Mynydd Ty-talwyn Energy Park - Environmental Statement Volume III

Appendix 1.2: Scoping Direction

EIA Scoping Direction

Mynydd Ty-Talwyn Energy Park

Figure 1 – Illustration of PROWs crossing the site.

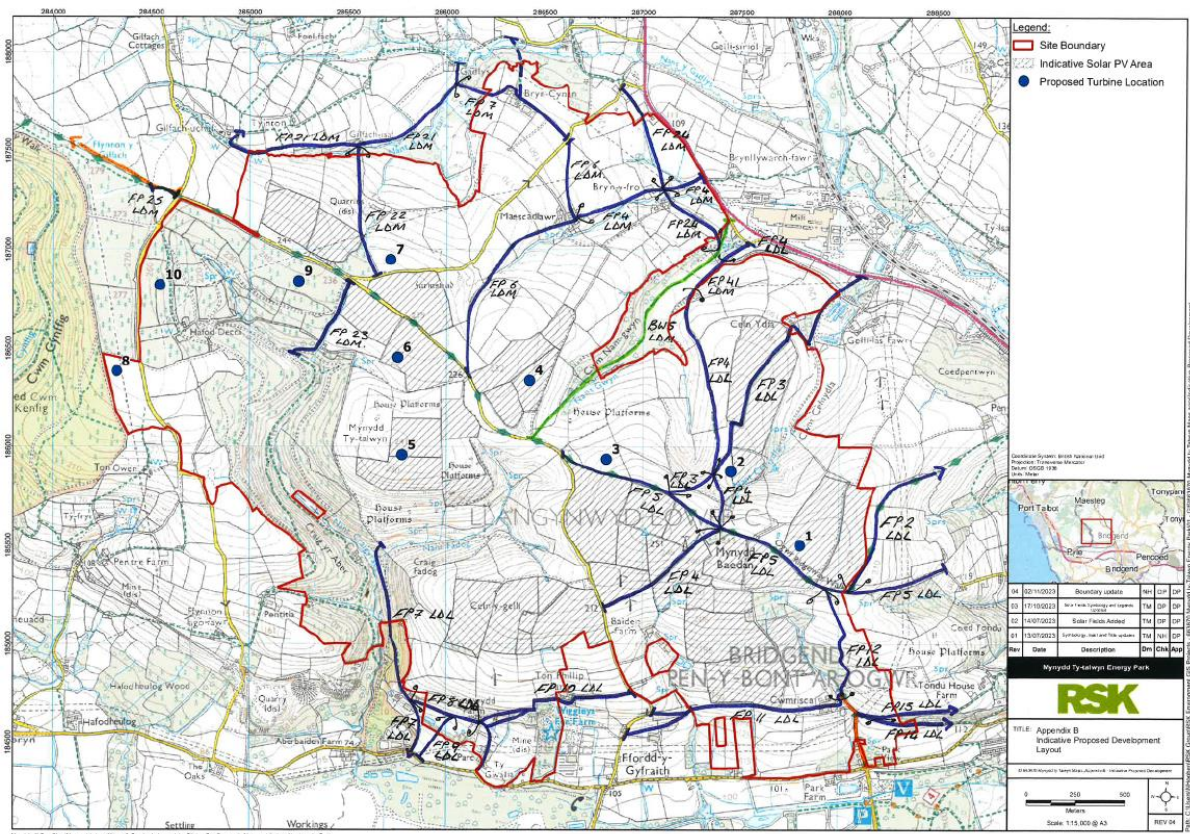
"The submission has been forwarded to the Rights of Way section for comment because it appears that the development may affect a public right of way. Indeed, following receipt of the application the Definitive Map was checked and I can confirm that the following registered public rights of way affect the application boundary of the proposed development (the approximate alignments of those footpaths and bridleway as are currently shown on the Definitive Map are shown coloured purple (Footpaths) and coloured green (Bridleway) on the indicative proposed development layout plan, a copy of which is attached herewith (See Appendix 1)):

It should be noted that two registered public footpaths also abut the application boundary of the proposed development. The approximate alignments of those footpaths, as they are currently shown on the Definitive Map, are shown coloured purple on the indicative proposed development layout plan. These are Footpath 2 Llangynwyd Lower (FP 2 LDL) and Footpath 25 Llangynwyd Middle (FP 25 LDM).

There are also 4 Definitive Map Modification Orders (DMMO's) affecting the area concerned, these are shown by solid orange lines on the indicative proposed development layout plan. Below is Bridgend County Borough Council's reference and a description of each DMMO.

Having taken into account all the points outlined above, I can confirm that the Rights of Way Section would object to planning application P/24/66/DNS until such time as the applicant not only contacts the Rights of Way Section to further discuss how they would wish to deal with the PRowWs on site as well as the OAMP but also provides written confirmation that it will include the Bridgend Local Access Forum in any future consultations on the proposed development and the preparation of the OAMP.”
